NOTE:
CHANGES TO SHEETS 1, 3, 3A, 4, 6, 9C
NEW SHEETS 1, 10D

Designed: 9/28/16	MODIFICATION LEVEL		CIRCUIT MODIFICATIONS ARE NOT TO BE MADE WITHOUT AUTHORITY FROM THE OFFICE OF SIGNAL DESIGN	Date: 09/28/16	UNION PACIFIC RAILROAD
REVISE ROAD ANGLE AND LOOPS AT LINCOLN STREET M.P. 150.07	G. A. LAST LEVEL CHECKED	DU		Des: NST	LAWNDALE, ILLINOIS LINCOLN STREET SPRINGFIELD SUBDIVISION
	LAST LEVEL MOD THIS TYPICAL	DU		Chk: NBT	
	LAST LEVEL BY DESIGNER	DU		AFE: 22821	Office of AVP Engineering - Signal Omaha, Nebraska
Rec#: WO#: 22821	CHANGED FROM TYPICAL?	Y			
IS: NBT NST/JVJ	REV 01.24.11 4K 2TKEGMS.1

Sh.:	1
DOT	290978H
MP:	150.07
ID:	CSL15007.1X

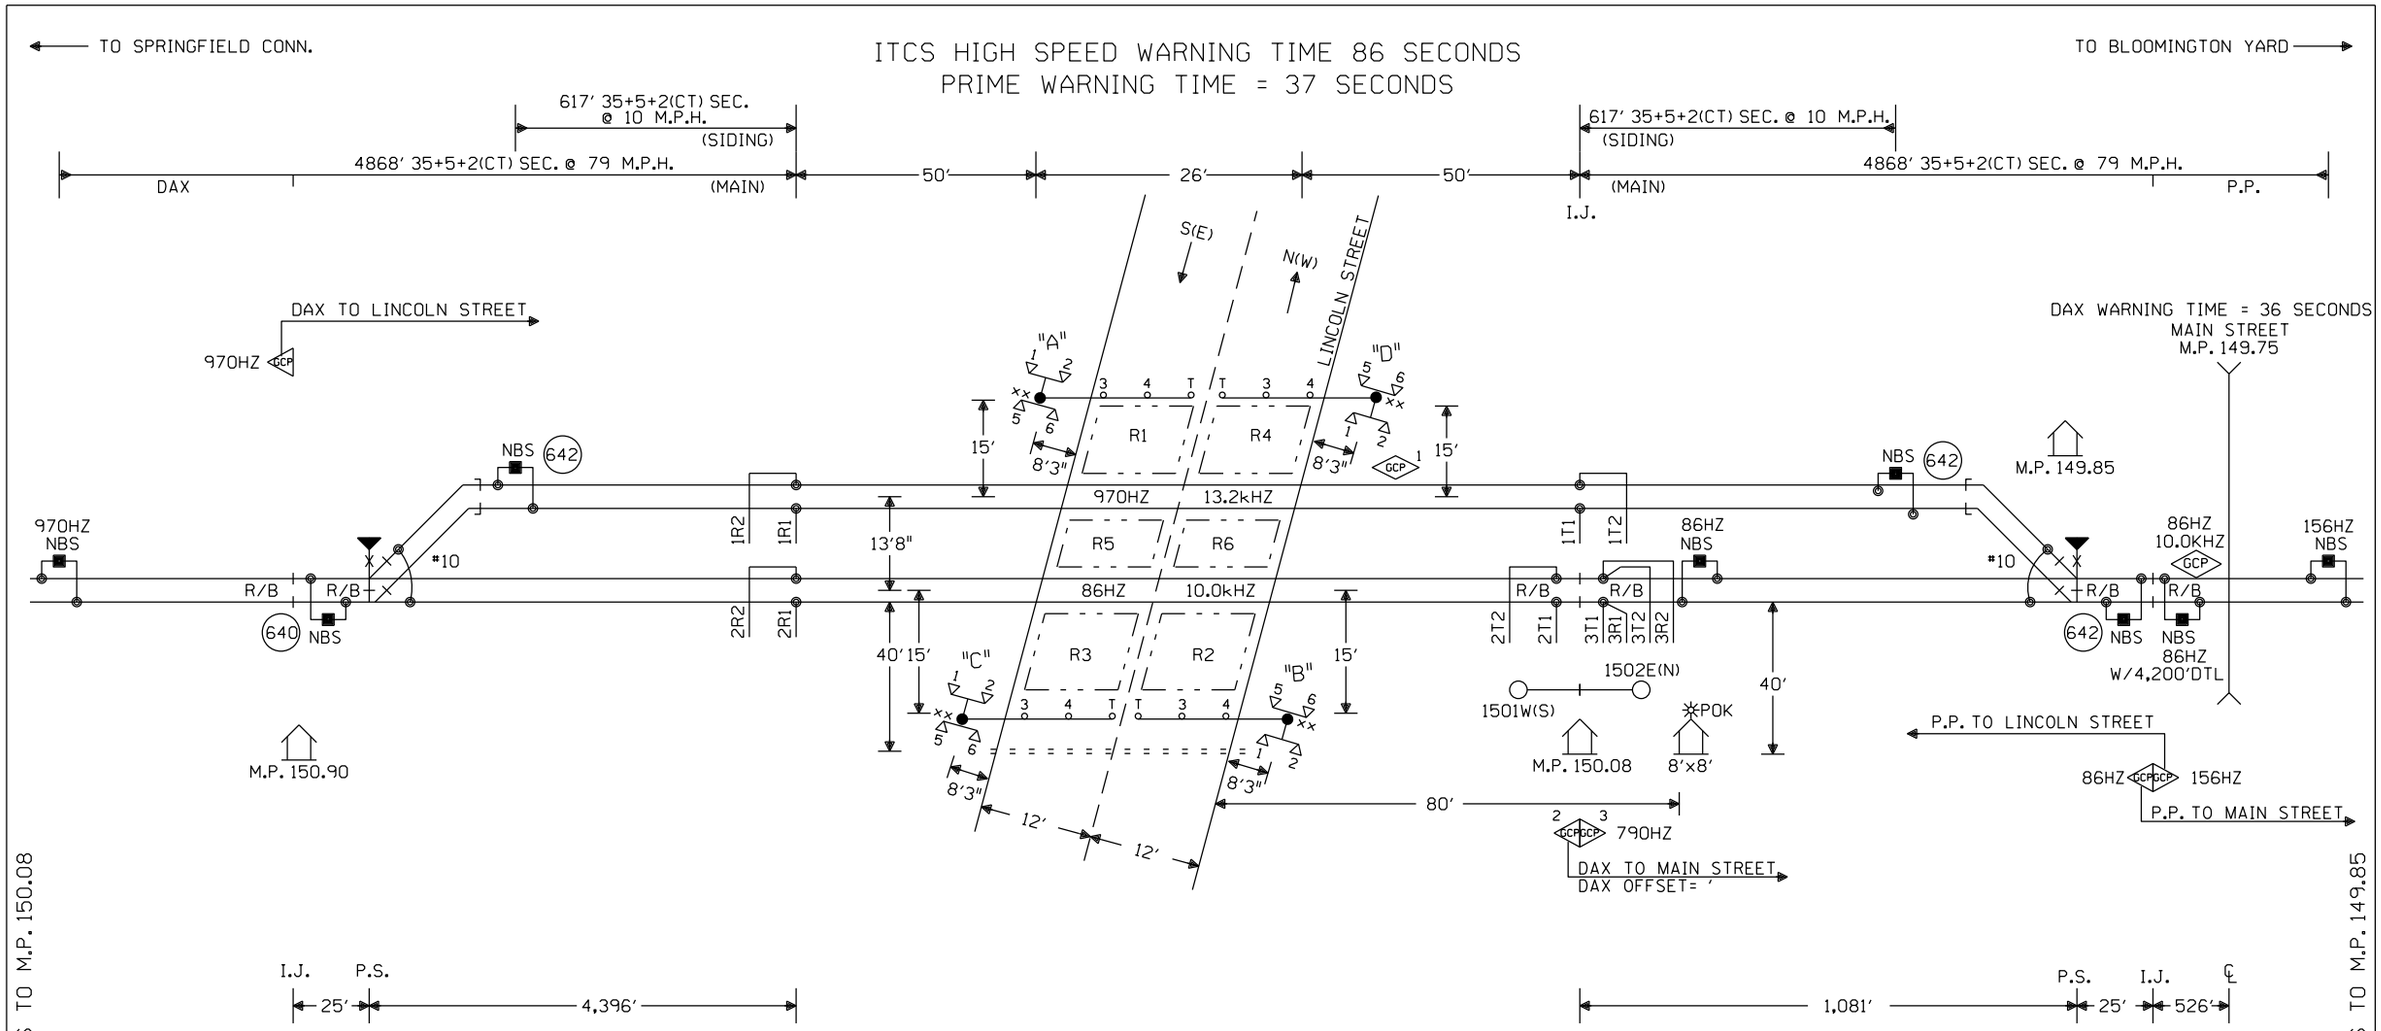
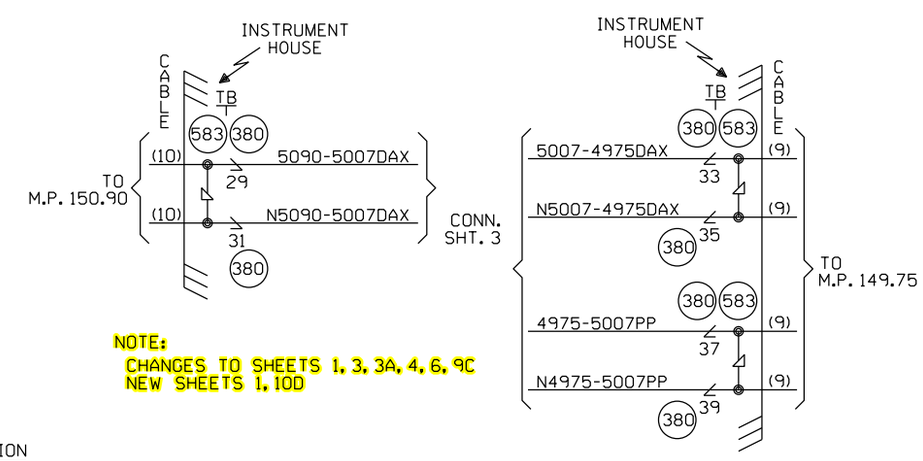
1. REUSE EXISTING 8'X8' HOUSE.
2. REUSE AND RELOCATE EXISTING GATES TO BE 15' FROM CENTERLINE OF CLOSEST TRACK AND 8'3" FROM EDGE OF ROAD.
3. REPLACE ALL VEHICLE DETECTION LOOPS.

Sh.: 3
DOT 290978H
MP: 150.07
ID: CSL15007.3X

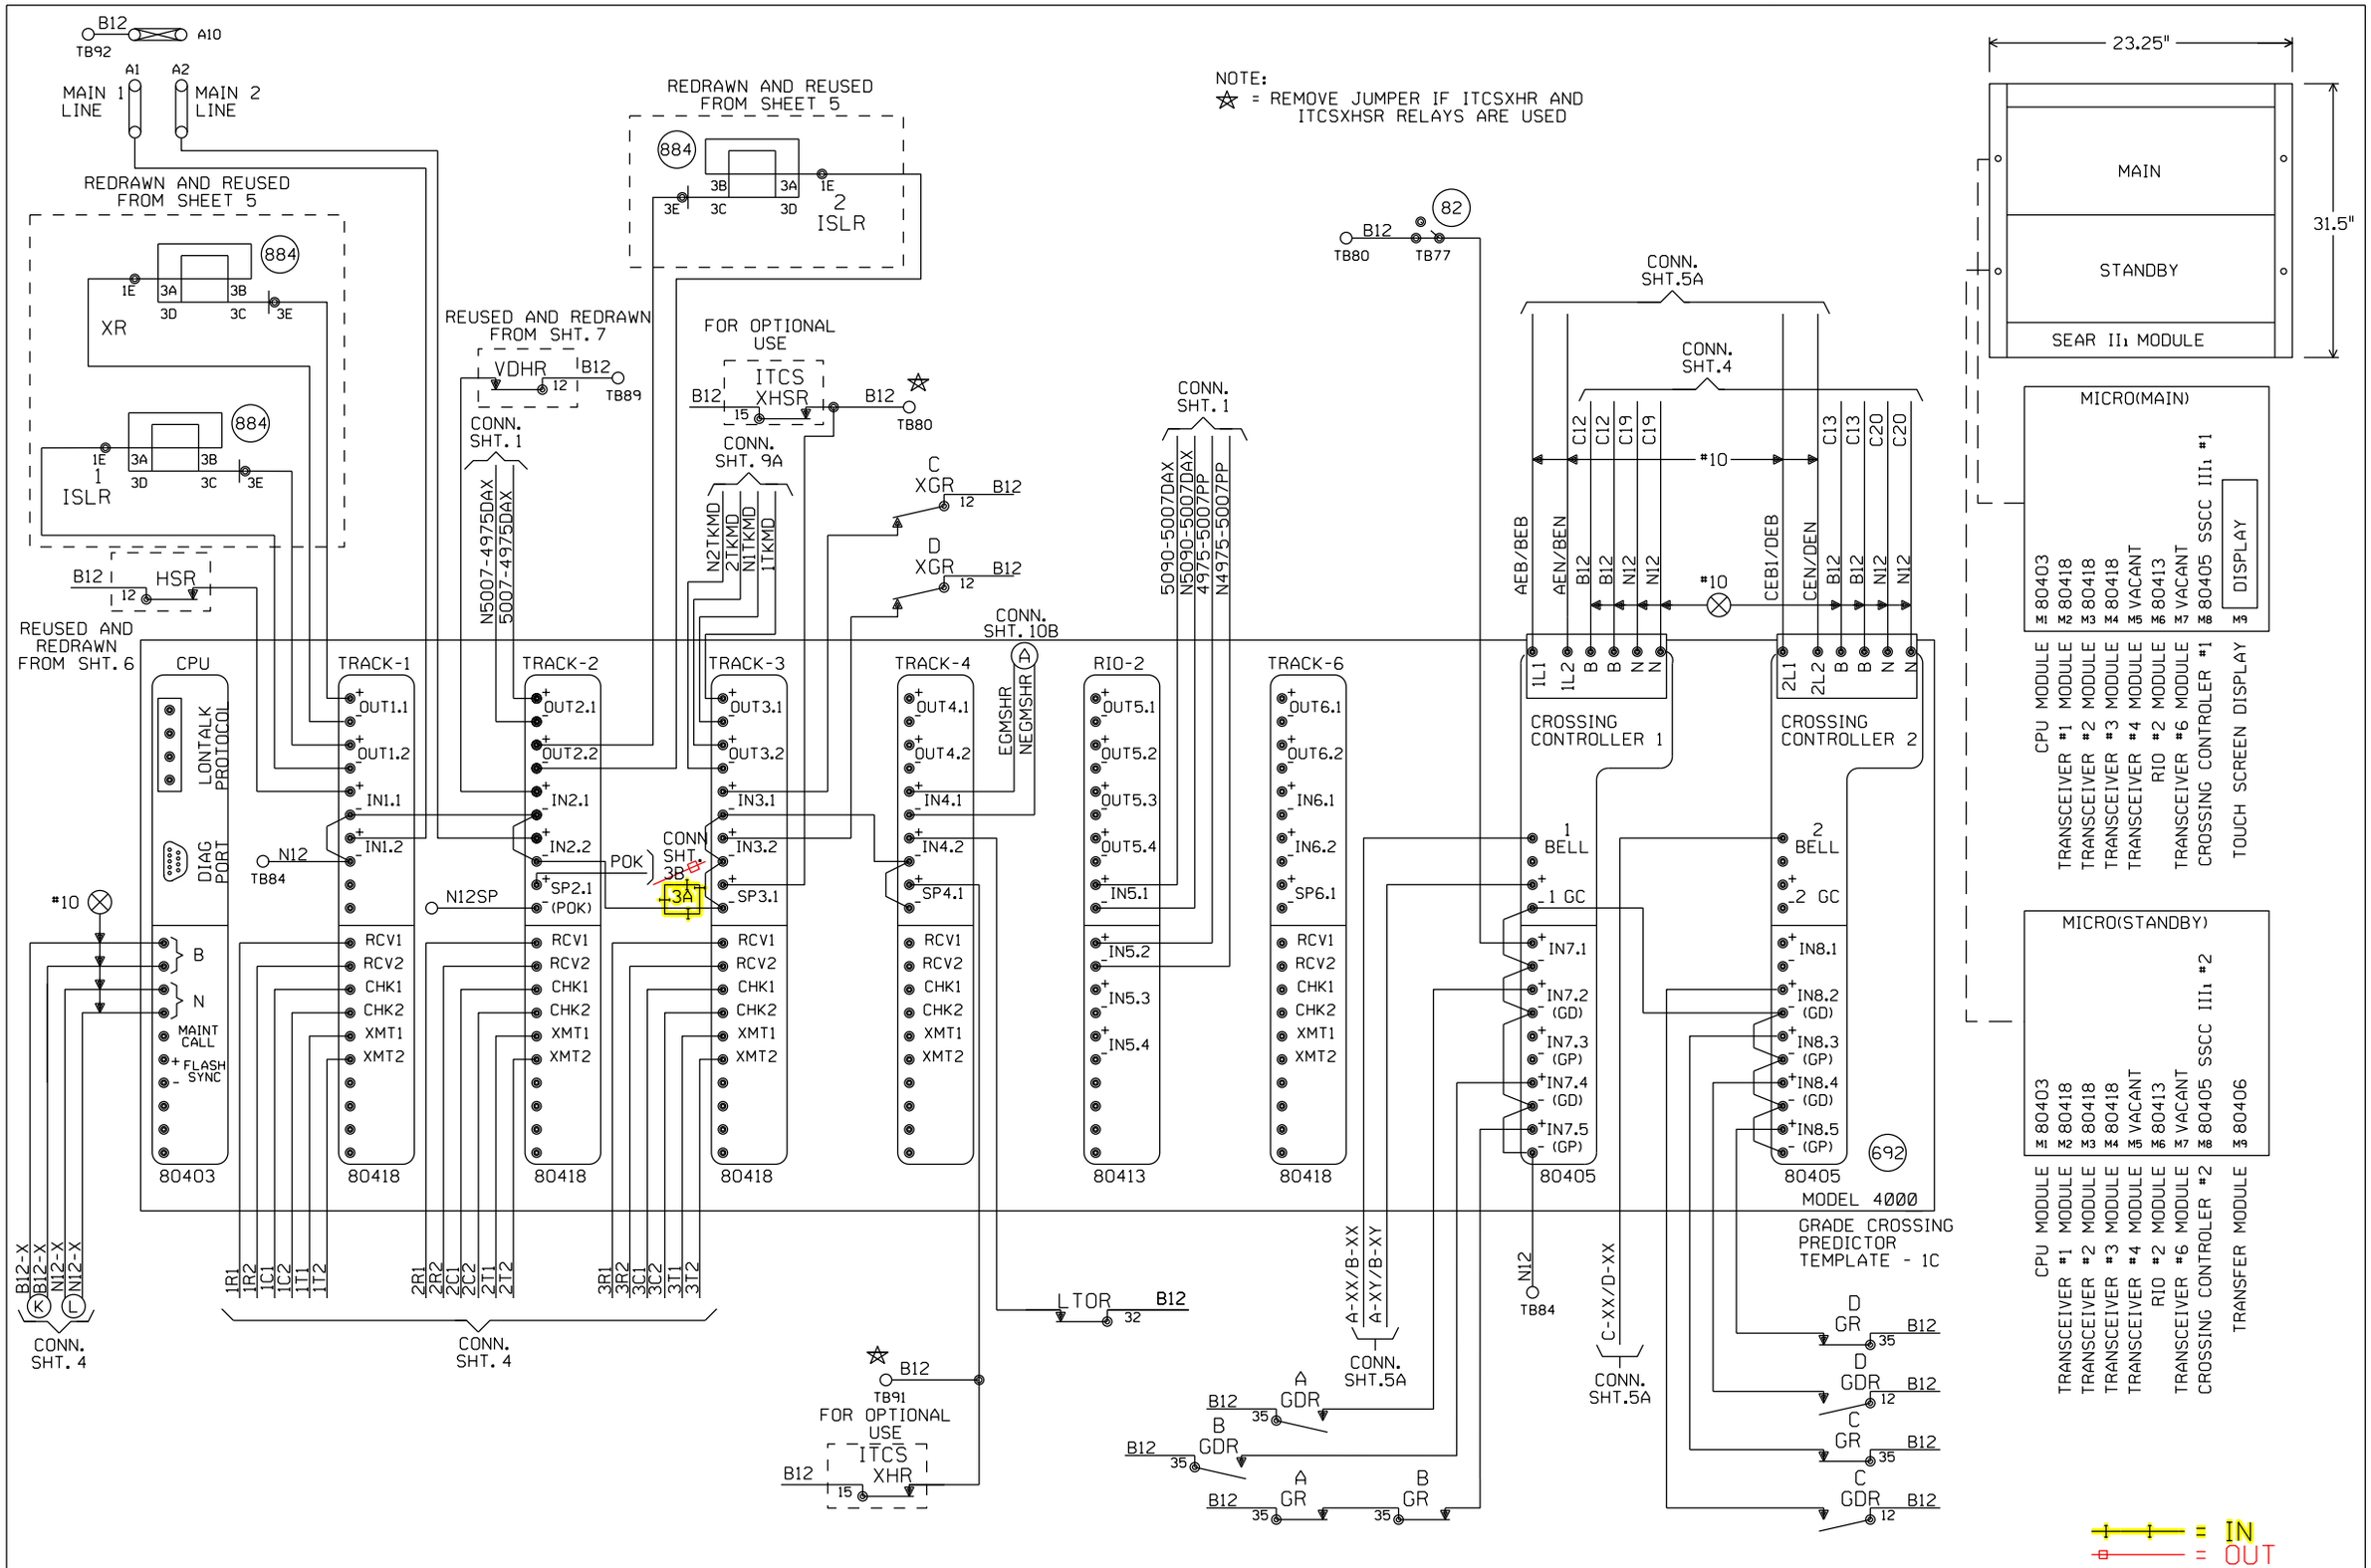
Designed: 9/28/16
REVISE ROAD ANGLE AND LOOPS AT LINCOLN STREET M.P. 150.07
Rec*: WO*: 22821 /NBT
IS: /NST/JVJ

Sh.: ~~3B~~ 3A
DOT 290978H
MP: 150.07
ID: CSL15007.3B~~X~~ 3AX

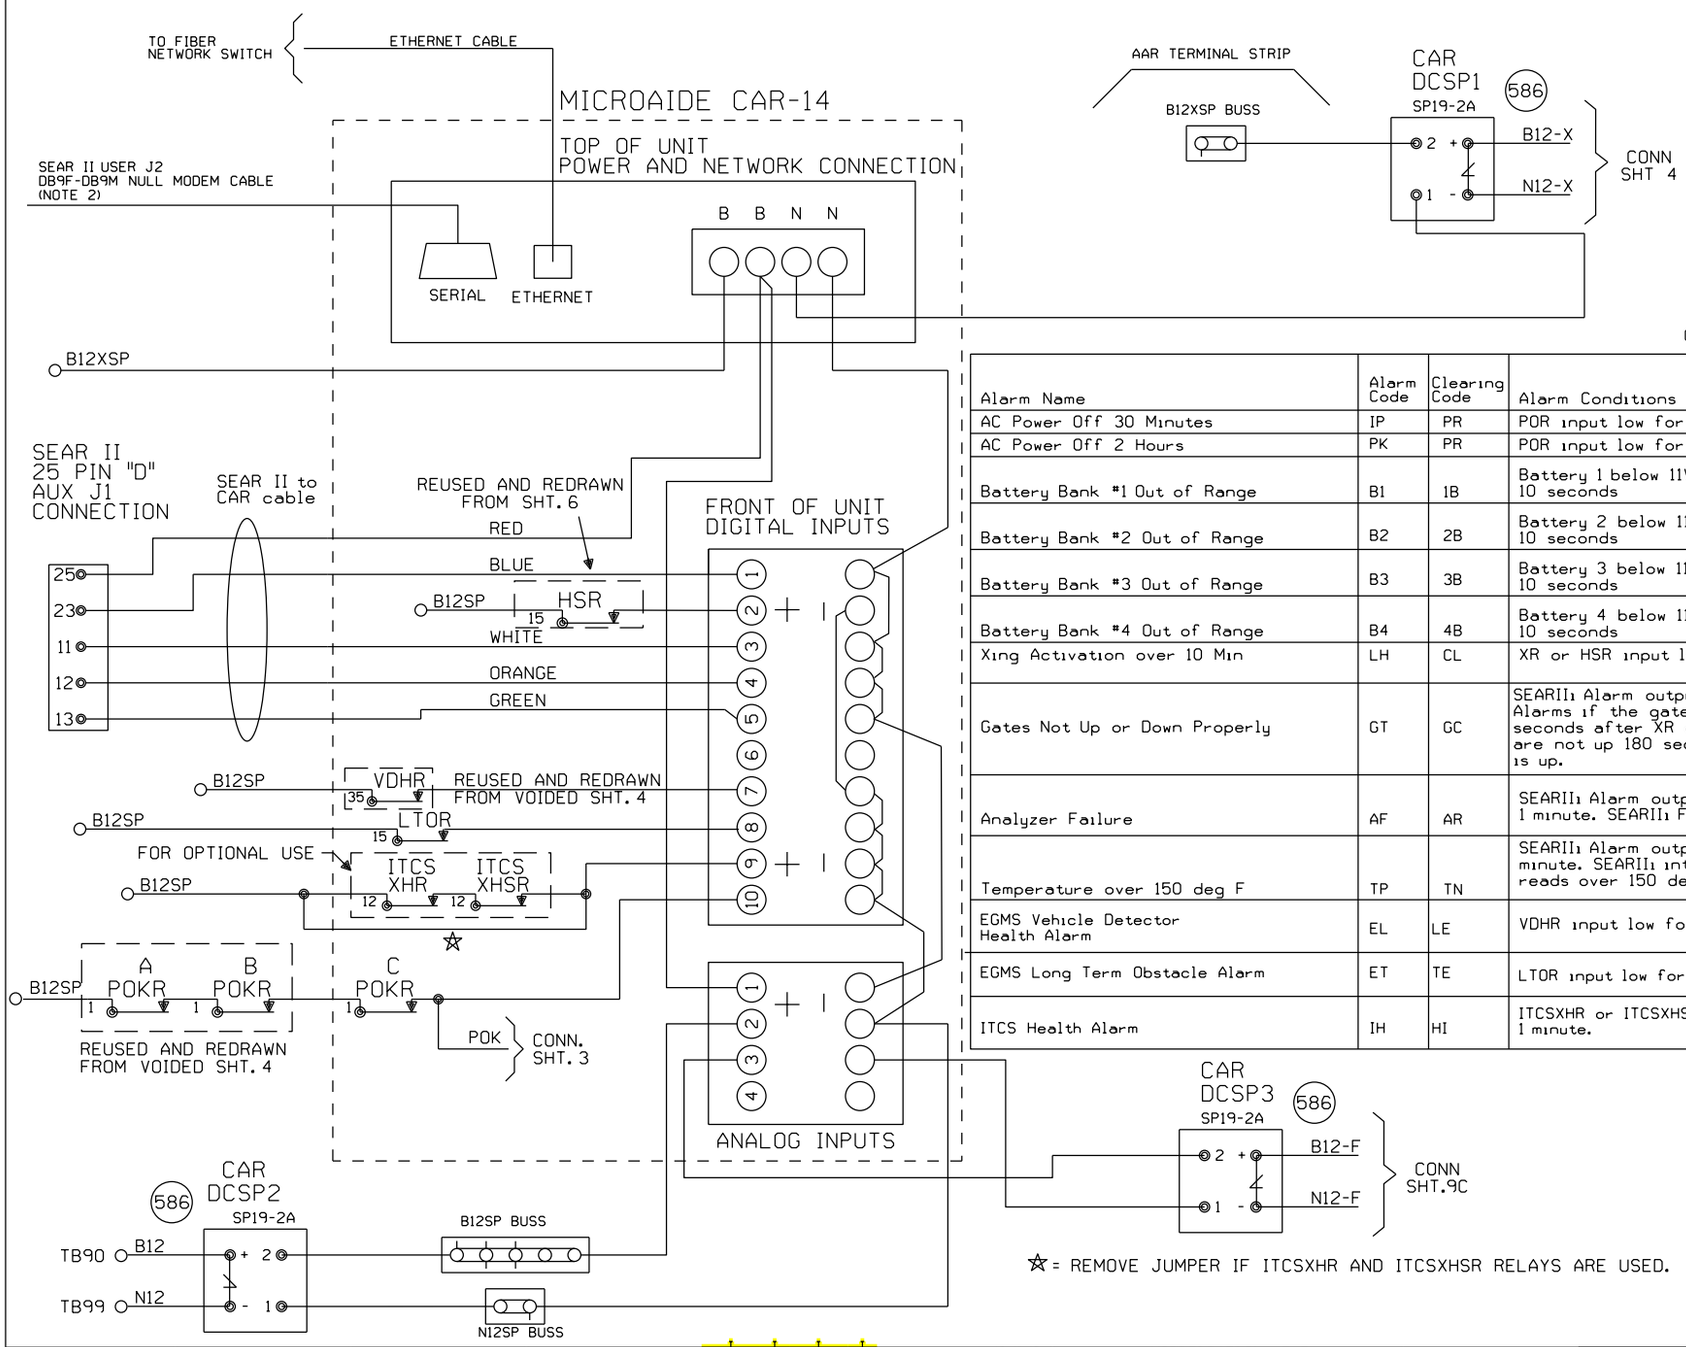
Designed: 4/28/16
REVISE ROAD ANGLE AND LOOPS AT LINCOLN STREET M.P. 150.07
Rec#: WO#: 22821 /NBT
IS: /NST/JVJ
